Project	IEEE 802.16 Broadband Wireless Access Working Group < http://ieee802.org/16 >	
Title	Block Turbo Codes for 802.16 optional coding	
Date Submitted	2002-07-09	
Source(s)	Brian A. Banister Advanced Hardware Architectures 2345 NE Hopkins Court Pullman WA 99163-5601	Voice: 509-336-7108 Fax: 509-334-9000 bbaniste@aha.com
Re:		
Abstract	Demonstrates that the current optional coding scheme does provide material gains, correcting comparisons made in C802.16a-02/59.	
Purpose	Defend BTCs from claims made in C802.16a-02/59	
Notice	This document has been prepared to assist IEEE 802.16. It is offered as a basis for discussion and is not binding on the contributing individual(s) or organization(s). The material in this document is subject to change in form and content after further study. The contributor(s) reserve(s) the right to add, amend or withdraw material contained herein.	
Release	The contributor grants a free, irrevocable license to the IEEE to incorporate material contained in this contribution, and any modifications thereof, in the creation of an IEEE Standards publication; to copyright in the IEEE's name any IEEE Standards publication even though it may include portions of thi

Figure 1, Optional channel coding for rate 3/4 QPSK OFDM mode in AWGN.

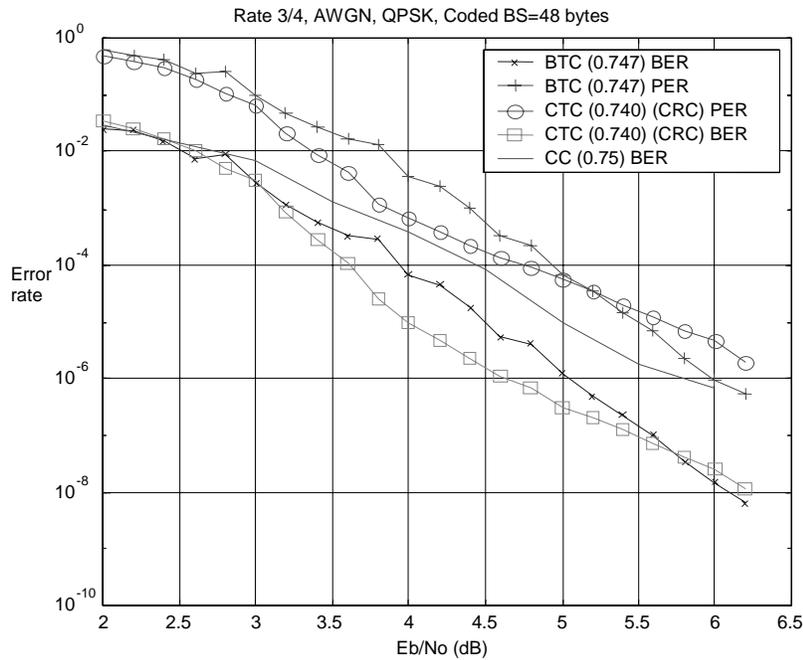
For the optional mode of rate $3/4$, QPSK OFDM mode in AWGN, it is observed and conceded that the CTC offers an improvement on the order of 0.5 dB at a BER of $1e-6$. However, shortly below $1e-6$, the performance of the CTC begins to degrade as it hits its error floor. By a BER of $1e-8$, it is observed that the BTC offers gain beyond that of the CTC. The BER advantage of the BTC increases for increasing SNR. It is also noted that the packet error rate (PER) of the BTC is superior to the CTC for PER below about $5e-5$.

Figure 2, Optional channel coding for rate 3/5 16-QAM OFDM mode in AWGN.

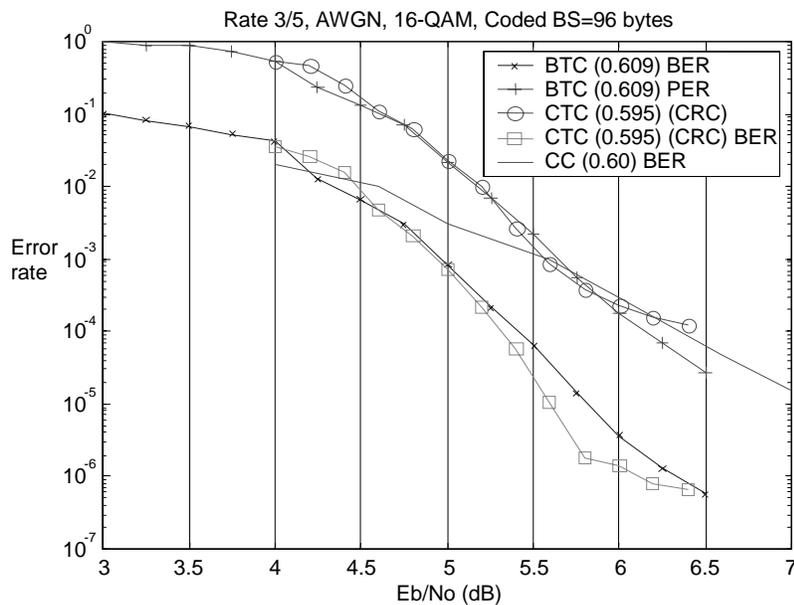
For the optional mode of rate 3/5, 16-QAM OFDM mode in AWGN, very similar BER and PER rates are observed for BER above 1e-4 and PER above 1e-4. Below 1e-4, and prior to the CTC reaching the error floor, the CTC gains up to an additional 0.3 dB. The error floor is seen in the figure to begin around a BER of 1e-6, with the BTC expected to have the advantage below a BER of 1e-8. For the PER, the BTC begins to have an advantage at 1e-4.

Figure 3, Optional channel coding for rate 2/3 64-QAM OFDM mode in AWGN.

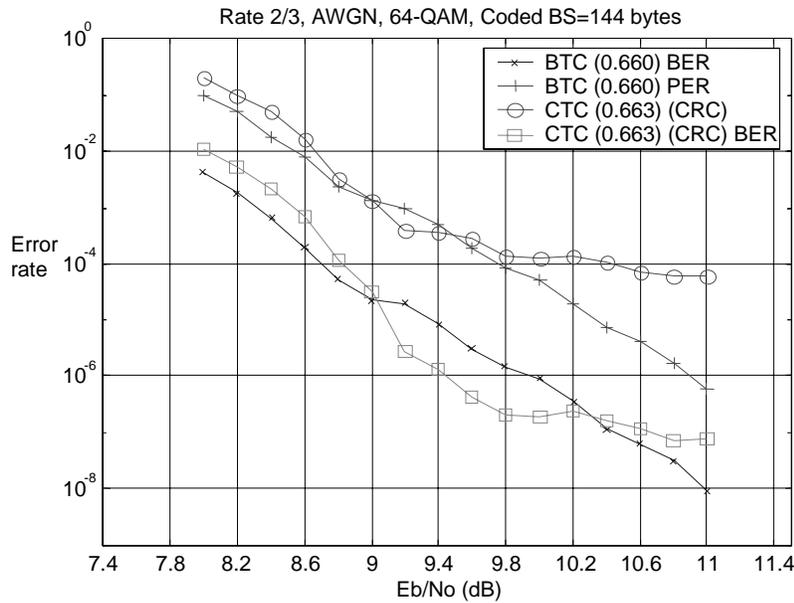
At higher throughput rates, obtained by higher order modulation schemes and accompanied by larger block sizes, the CTC error floor becomes even more of a detriment. As seen in Figure 3, the PER for the CTC is significantly impacted by the error floor, with a factor of 100 difference in packet error probabilities between the BTC and CTC at E_b/N_0 of 11 dB. As observed in the earlier figures, we note that the CTC does provide an additional gain over the BTC at a BER of $1e-6$, but loses this advantage at lower BERs.
